Architectural Review Board Agenda
4:00 PM Wednesday, May 7, 2025
Sussex Civic Center – Committee Room Second Floor

- I. **Roll call.**
- II. **Consideration and possible action on the ARB minutes of April 2, 2025.**
- III. **Discussion and possible action on a Plan of Operation, site plan, landscape plan, architecture plan, and lighting plan for a building expansion for Adron located at W251N5490 Business Dr.**

PROPOSED BUILDING ADDITION FOR:
ADRON TOOL CORPORATION
W251 N5490 BUSINESS DRIVE
VILLAGE OF SUSSEX, WI

LANDSCAPE PLAN

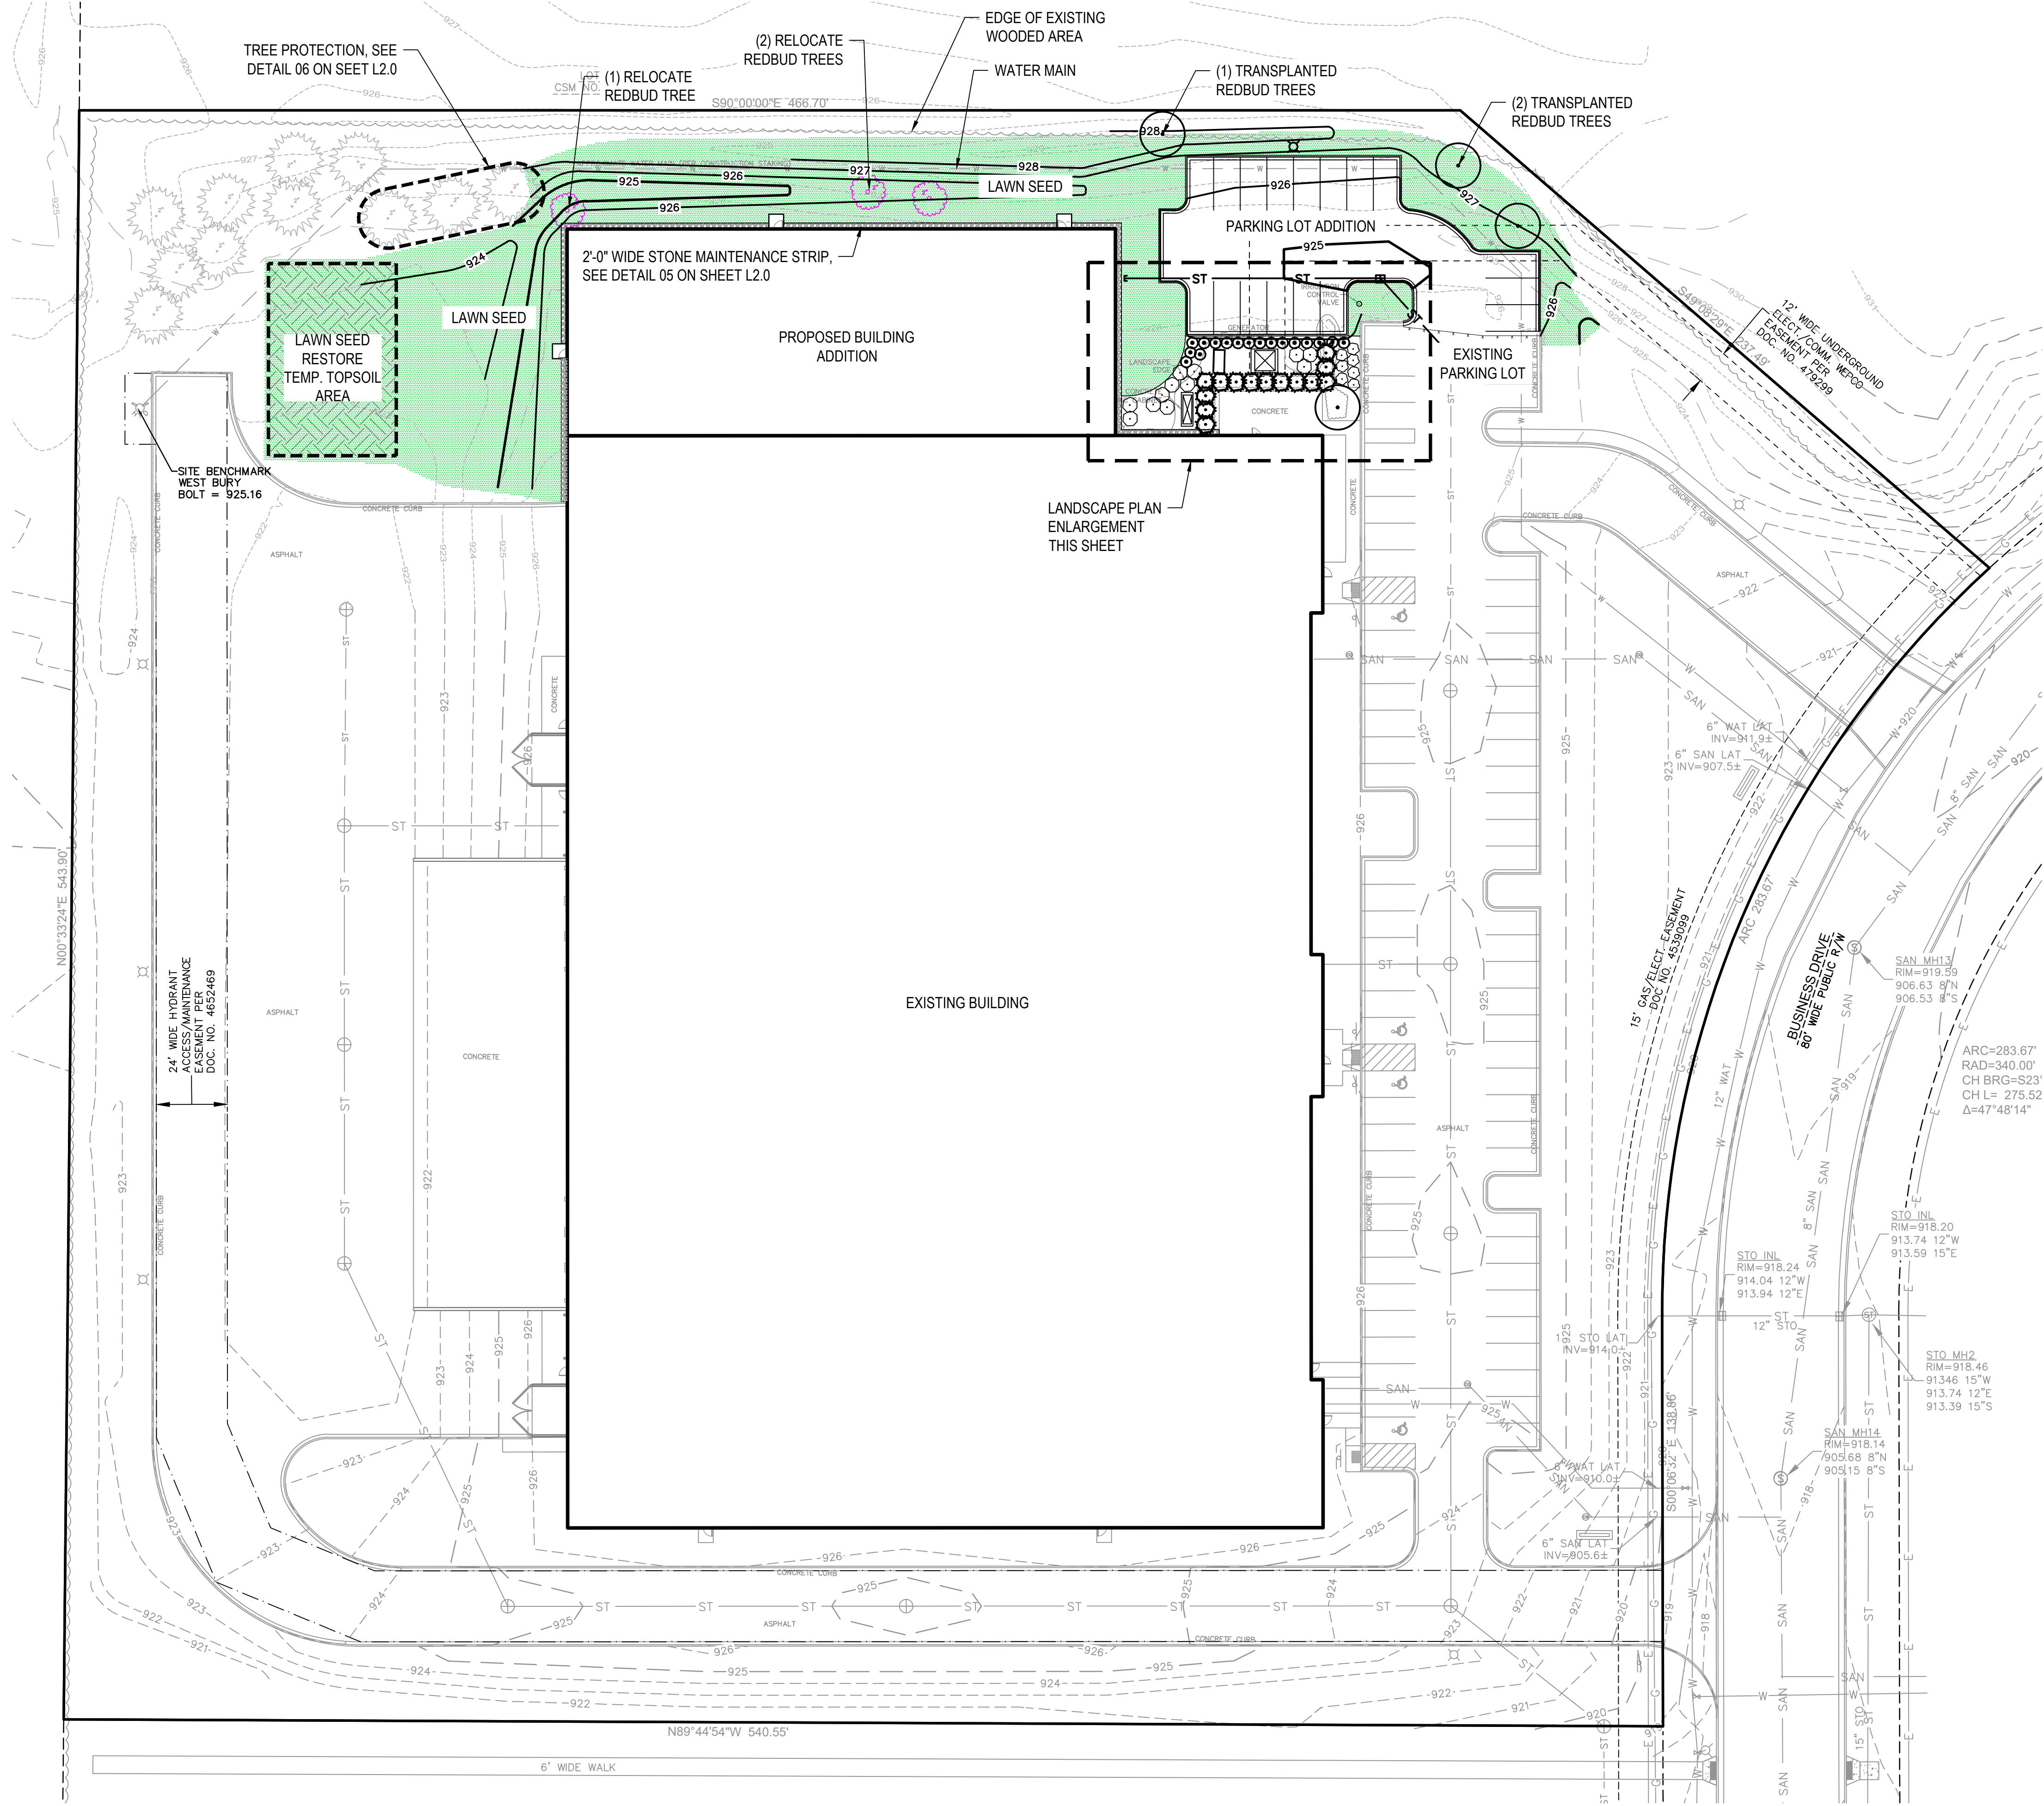
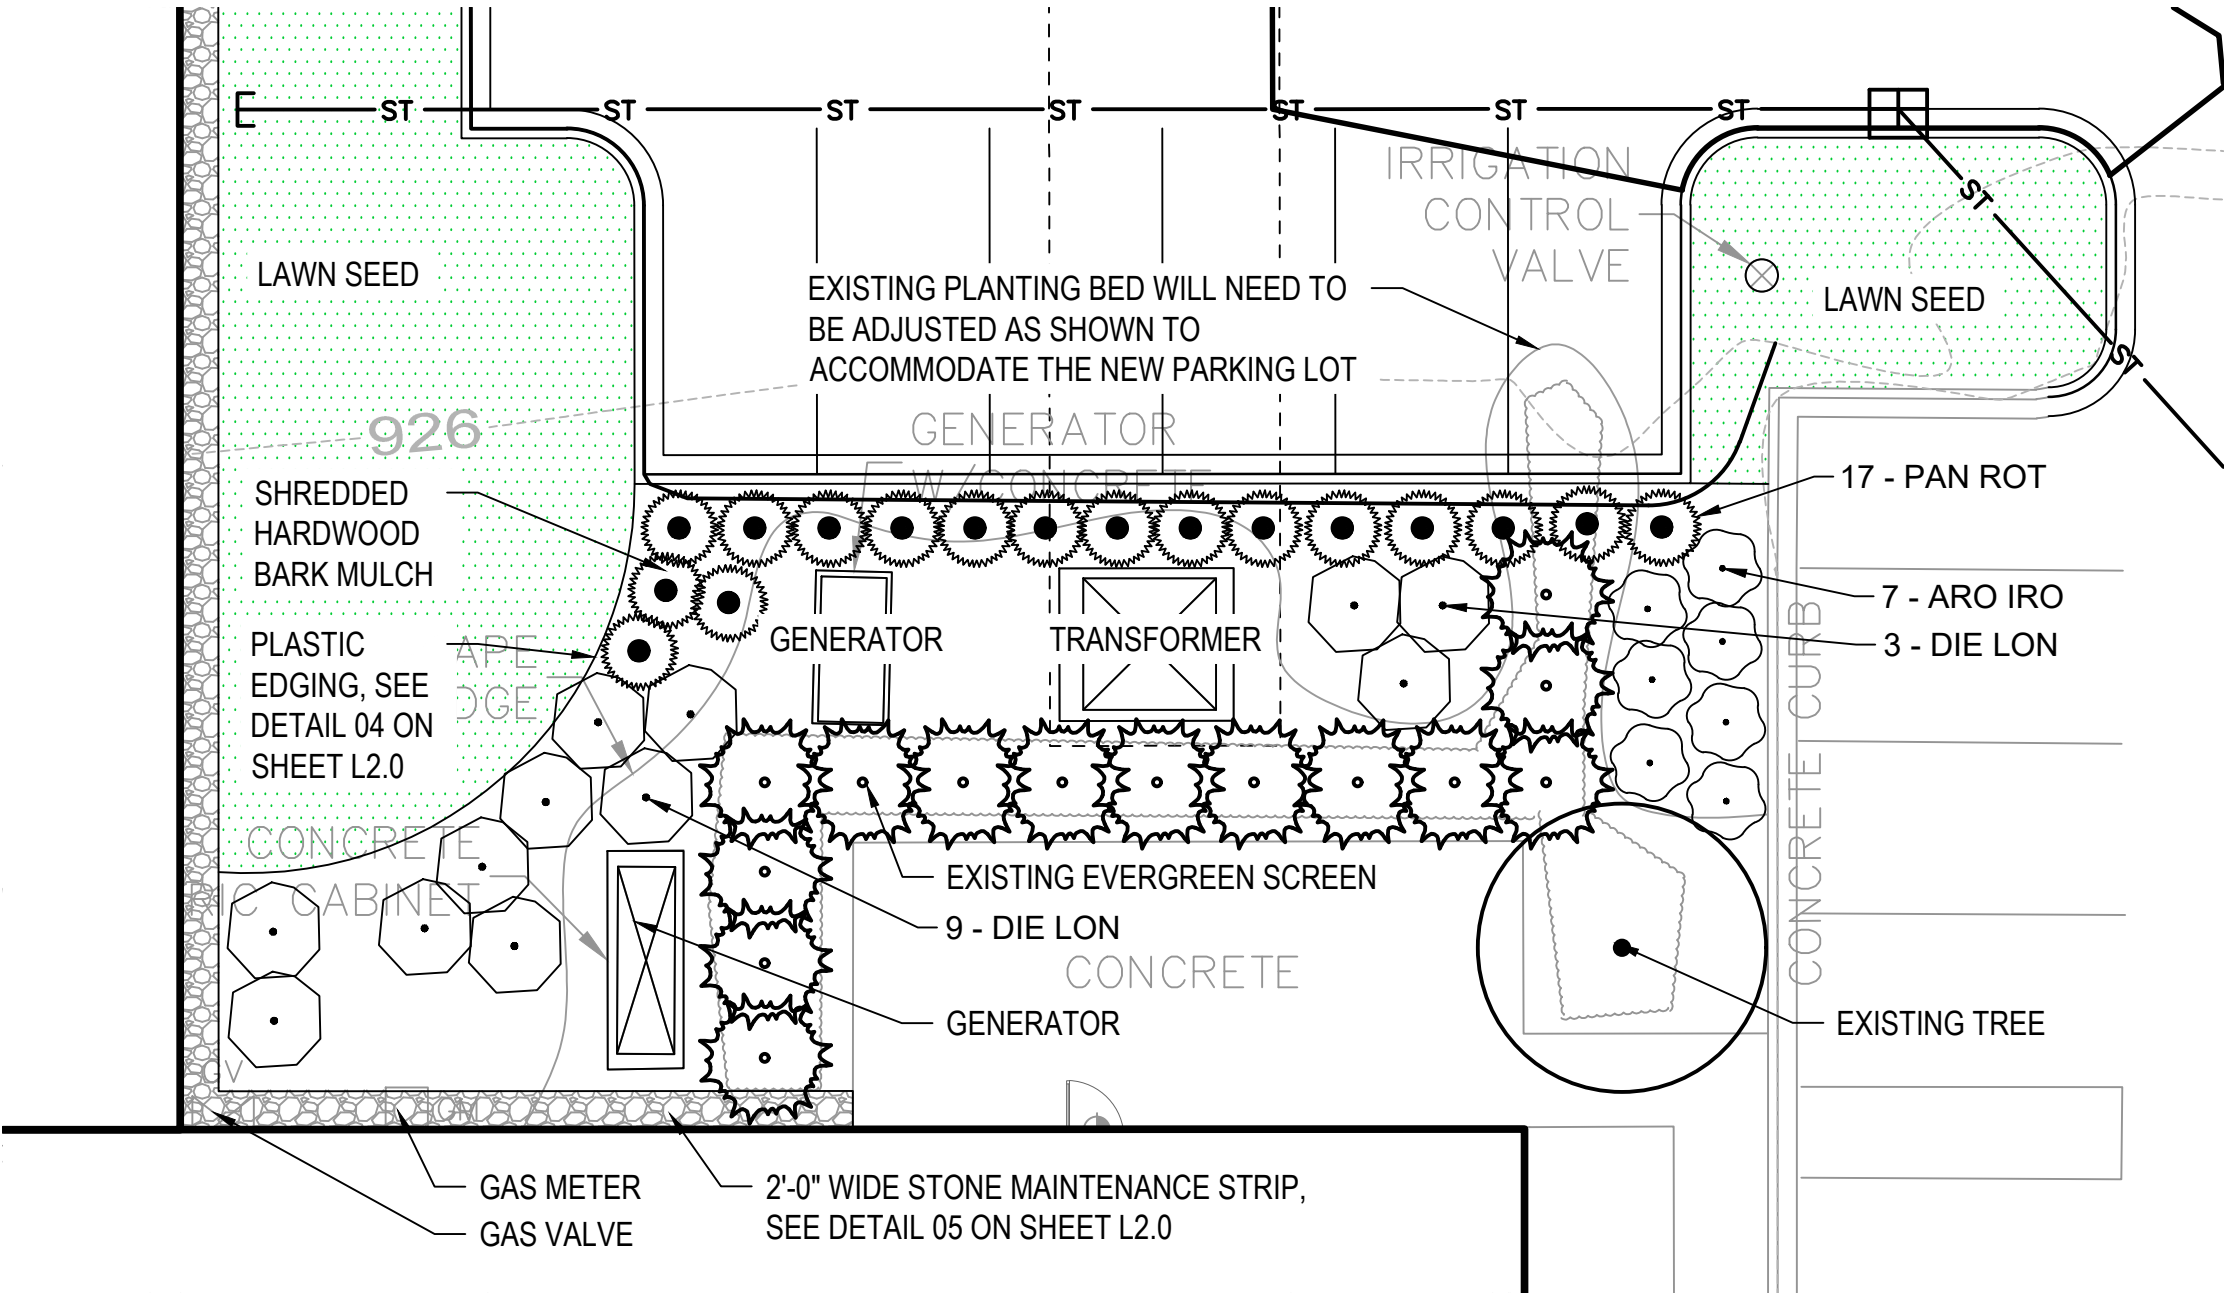
- Additional plants have been added to compensate for the additional street elevation and meets the minimum design guideline requirements.

1. Compliance with any comments and conditions of the Engineering Department.
2. All rooftop mounted HVAC units shall be screened.
3. Submitting a revised landscape plan that includes 3 additional trees to meet the minimum requirements of the Sussex Design Standards.
4. Submitting revised elevations that include the overall window and door opening percentage on the street elevation.

OVERALL EXTERIOR ELEVATIONS & PANEL RELOCATION

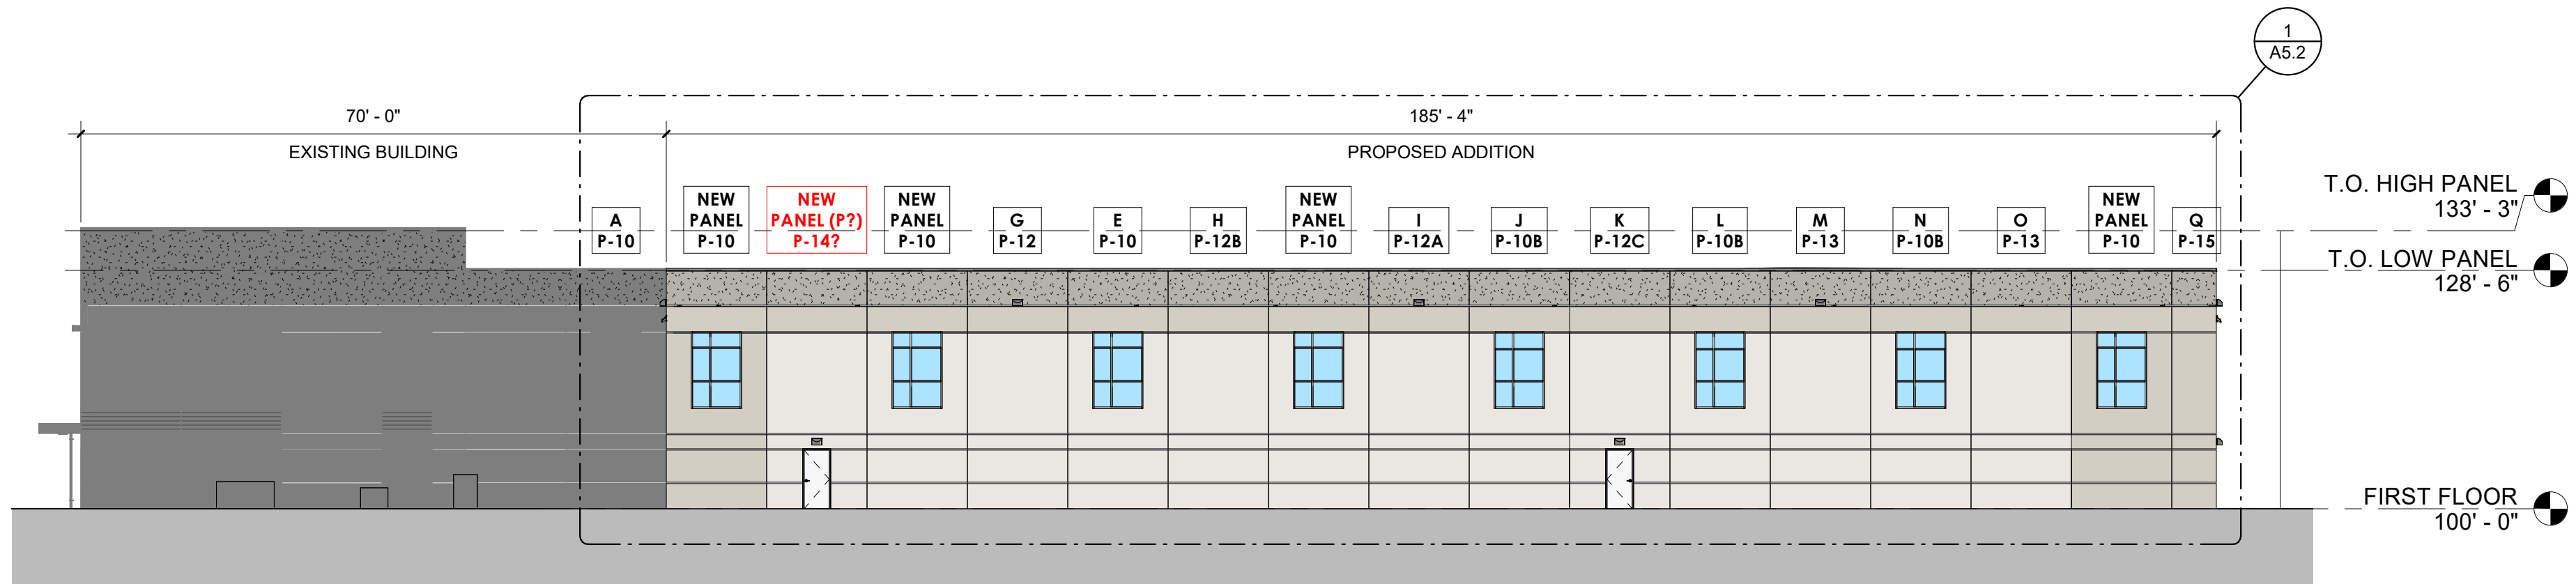
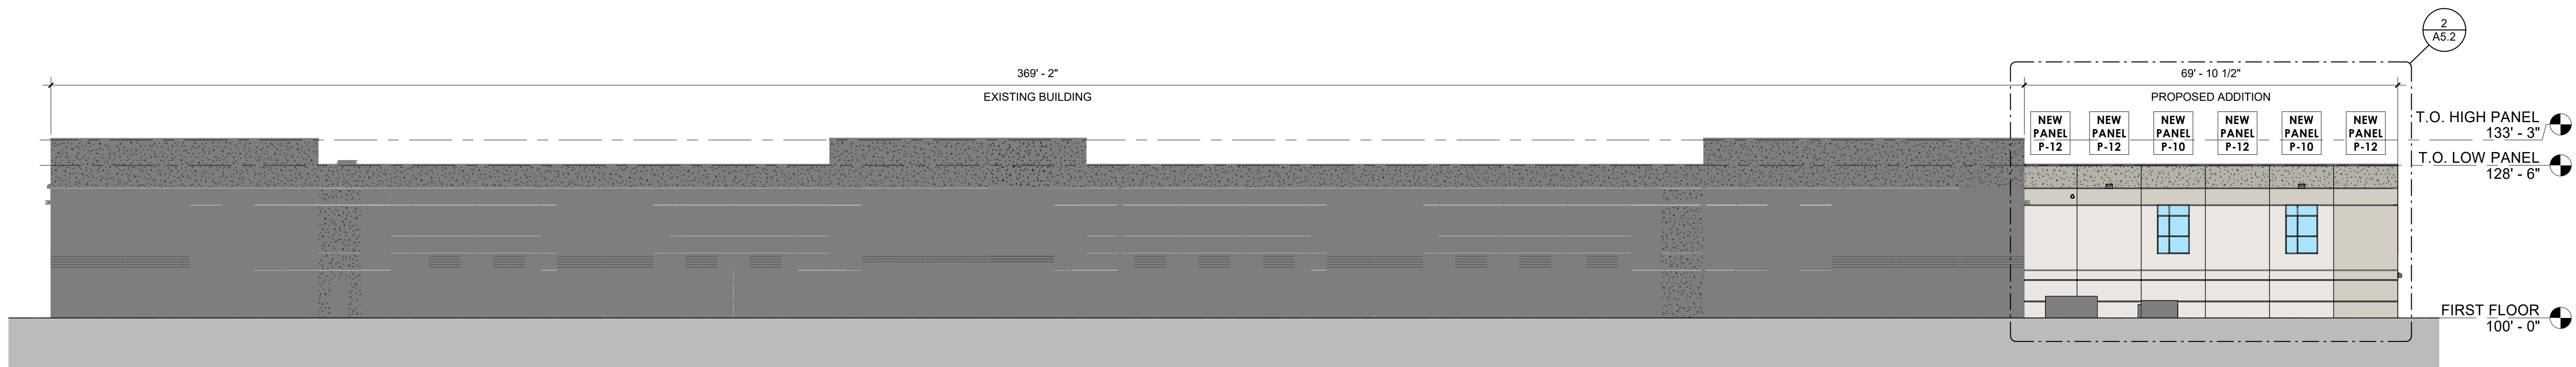
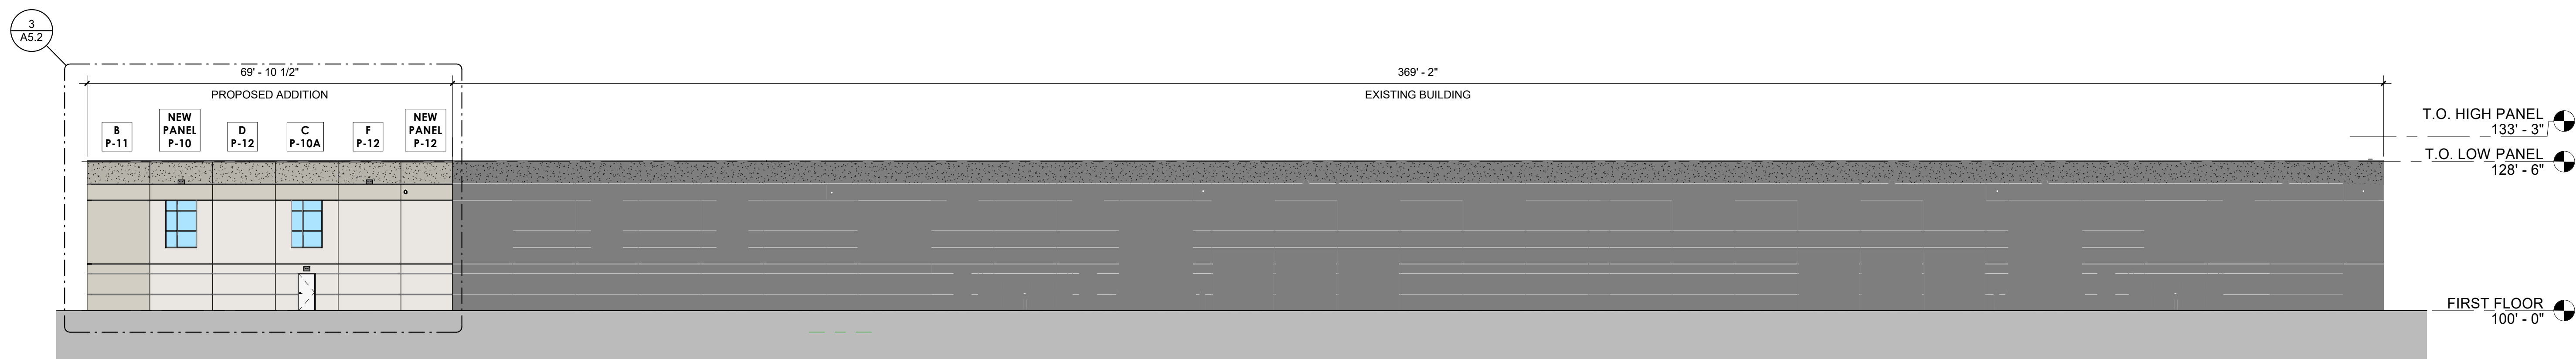
- Building meets height and required setbacks.
- Roof top units are to be screened from view.
- Materials to be used meets the Design Standards.
- The building meets the minimum window and door opening requirements.

1. Are there any concerns with the submitted site plans or plan of operation?
2. The applicant has asked the Board to consider alternatives for the RTU screening on the addition. This will be a policy decision for the Board to discuss.
